STAFF REPORT

AGENDA ITEM: 8243 Demontreville Trail N Conditional Use Permit

The Jesuit Retreat House recently submitted a conditional use permit application to amend an existing conditional use permit to allow the construction of a 10 person guest house at 8243 Demontreville Trail N (PID 0402921340004) with a building footprint of 5,555 square feet. Each guest room will have a full bathroom and the guest house is proposed directly northeast of the existing main building. The existing main building houses a dining room, kitchen, chapel, offices and meeting space. The applicant has indicated that the long term goal is to complete the proposed guest house and renovate existing guest homes to decrease the number of guest rooms and increase the number of toilets. As per the applicant, the additional guest house will not increase the capacity of the site long term. Some rooms in existing guest houses will be eliminated, then accounted for in the new guest house.

The Planning Commission is being asked to hold a public hearing, review, and make a recommendation on the requests to approve a conditional use permit amendment to construct a 10 person guest house.

SHEET LANDSCAPE PLAN

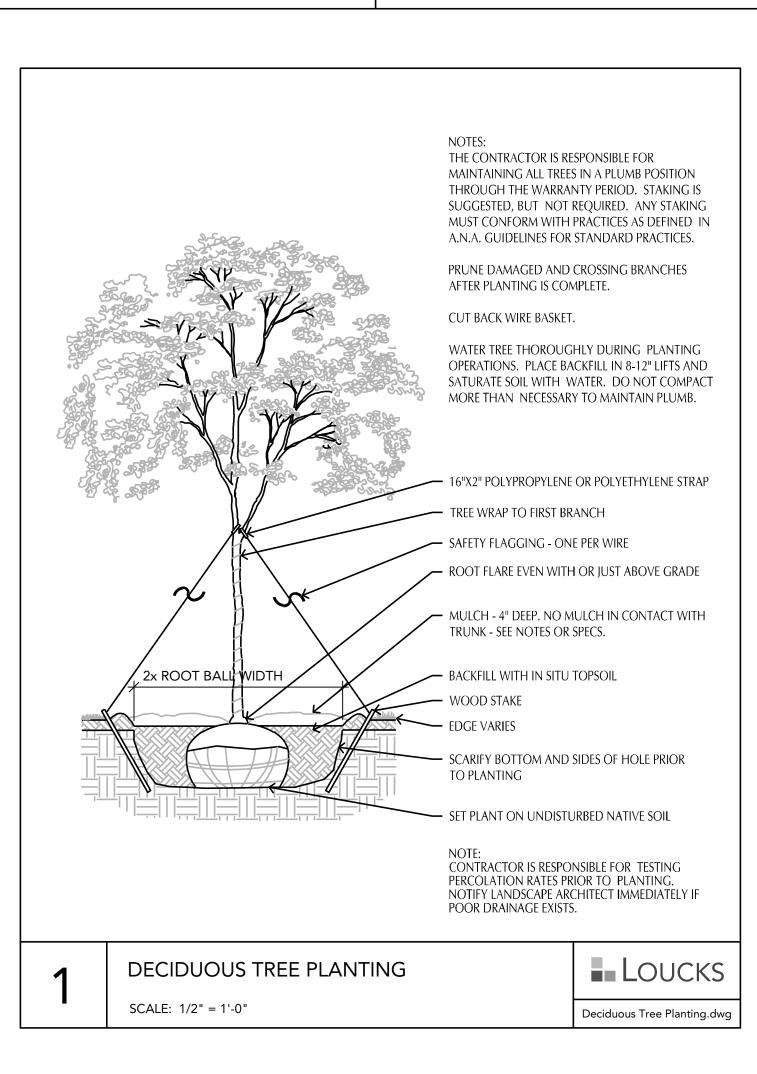
- 1. The applicant has demonstrated that a mitigation for a tree preservation plan is not needed as the overall site is wooded beyond those surveyed on the plan, thus does not exceed to 30% removal and replacement threshold.
- 2. A landscape plan has been submitted but does not meet all code requirements.
